Detailed Site Plan Departure of Parking and Loading Standards The Cassidy

DSP-21045
DPLS-22002

SUBJECT: Detailed Site Plan DSP-21045
Departure of Parking and Loading Standards DPLS-22022
Type II Tree Conservation Plan TCPII-077-04-03
The Cassidy

TYPE II TREE CONSERVATION PLAN

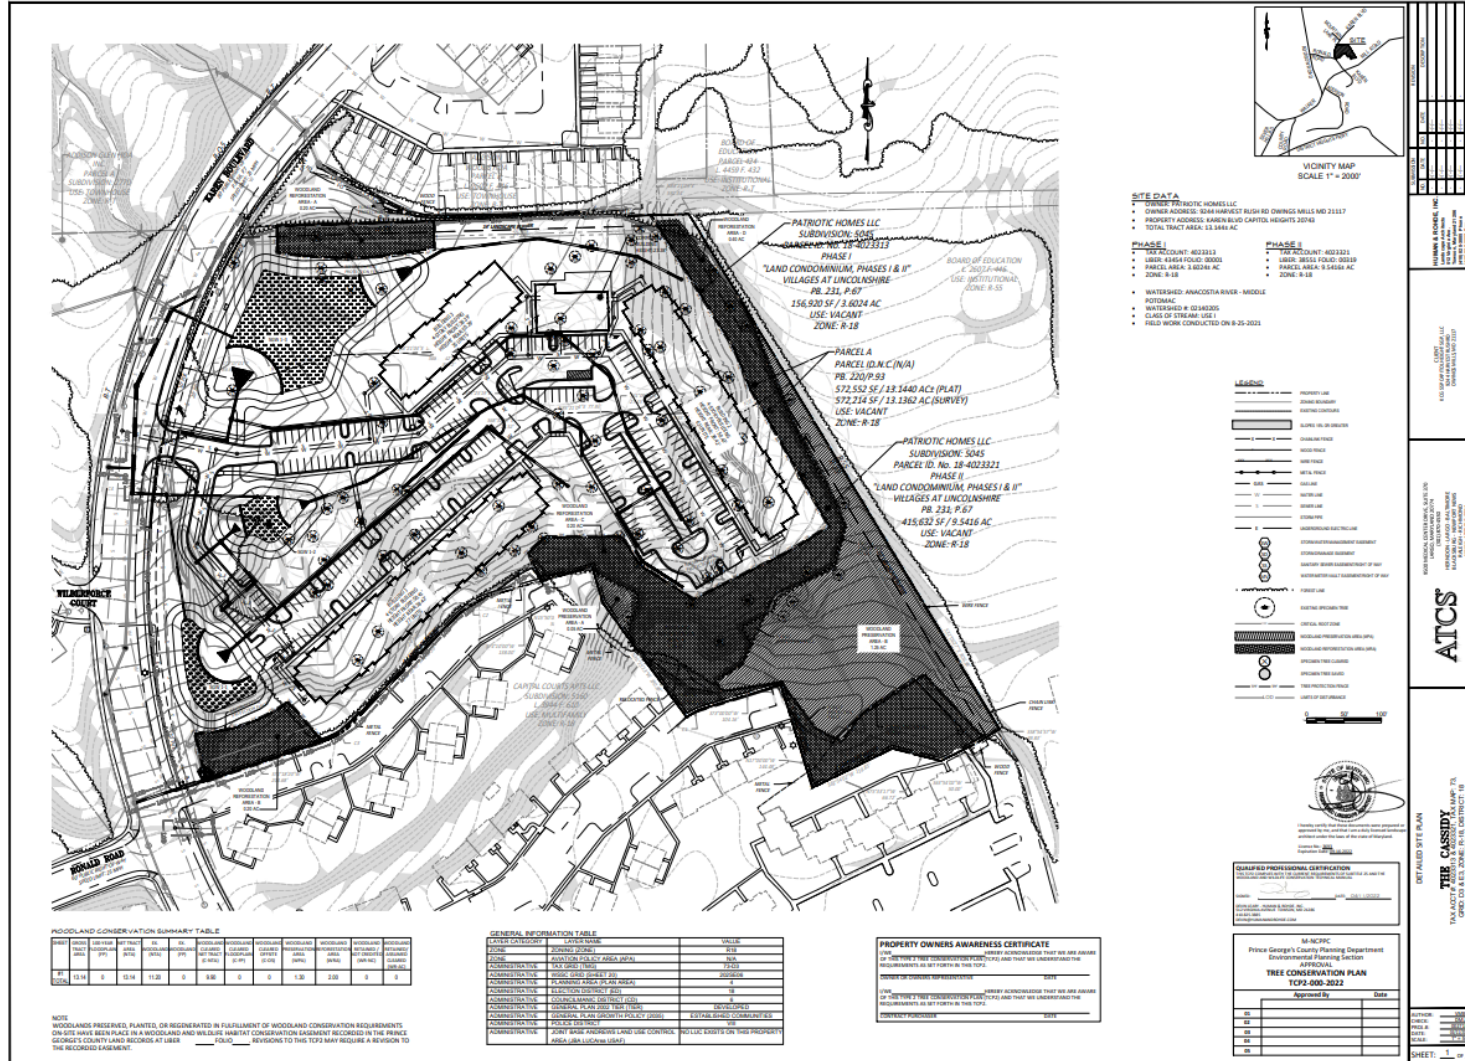
Prior to certification of the detailed site plan, the TCPII shall be revised as follows:

7. The woodland conservation worksheet shall be revised as follows:
 - a. Revise Line 6 to show Type II Tree Conservation Plan TCPII-077-04 for the TCPII number and indicate "3" for the revision number.
 - b. Add Type I Tree Conservation Plan TCPI-058-03 as the TCP1 number on Line 8.
 - c. Revise Line 17 to indicate Detailed Site Plan DSP-21045 for Phase II.

- d. Revise Line 18 to show that Detailed Site Plan DSP-05001 is associated with TCPII-077-04 Revision 1, and DSP-21045 is associated with TCPII-077-04 revision 3.

- e. Correct Line 1 to show that under the prior Zoning Ordinance this site is zoned Multifamily Medium Density Residential.
8. Update the Phase II Reforestation Planting Schedules to reflect 1,000 seedlings per acre. If larger plant material is proposed, then one seedling is equivalent to every 0.5-inch caliper. Each planting area shall be proposed with a minimum of five species. The general notes shall be revised, as follows:
